Commonwealth of Kentucky
**Kentucky State Board on
Electric Generation and
Transmission Siting**
211 Sower Blvd.
P.O. Box 615
Frankfort, Kentucky 40602-0615
Telephone: (502) 564-3940

Re: CASE NO. 2024-00105

Pike County KSB Site Visit – July 30, 2024

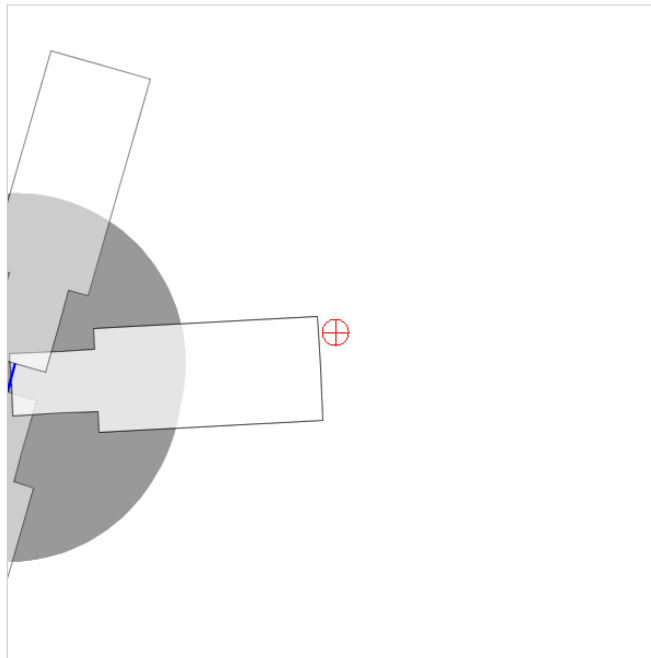
- Coordination with FAA

- Communicate and coordinate with airport. Notice Criteria Tool requires to file, will coordinate with FAA as necessary.

Your proposed structure is in proximity to a navigation facility and may impact the assurance of navigation signal reception. The FAA, in accordance with 77.9, requests that you file.
